BCA Design Assessment Report

Byron Bay Community Hub
10-12 Shirley Street, Byron Bay

Project: Byron Bay Community Hub
Document Type: BCA Design Assessment Report
Report Number: P221_011-1 (BCA) JR

Figure 1 Recommended discharge to Byron Street

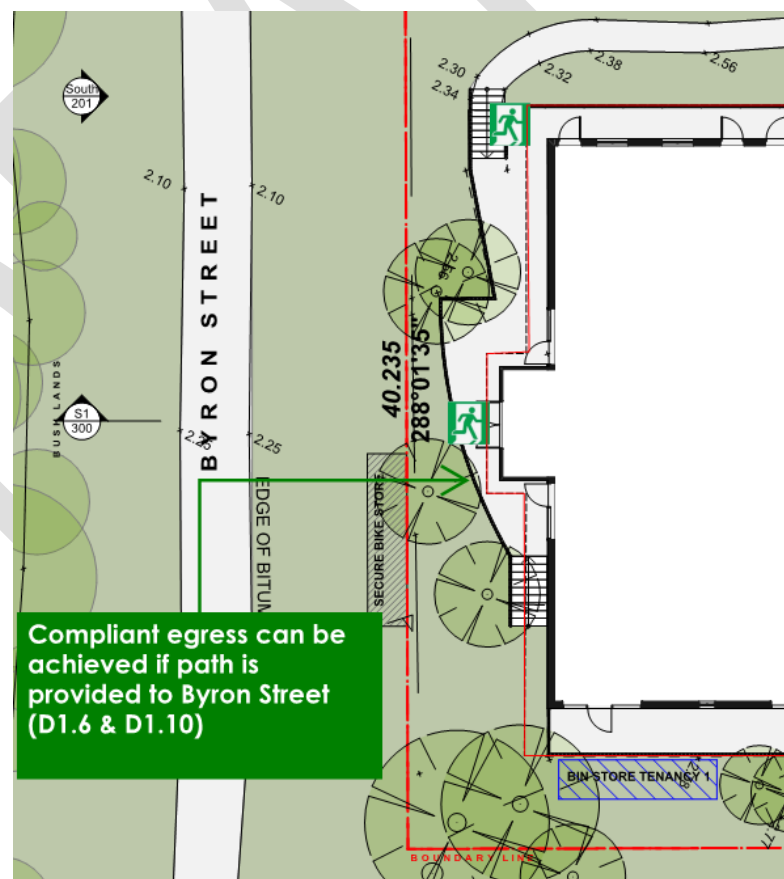
Travel distances have been assessed as capable of complying with the above provisions, however to facilitate compliant distances to road/ open space from Tenancy 1 confirmation is required that egress to the nearby streets/ laneway can be achieved through the landscape.
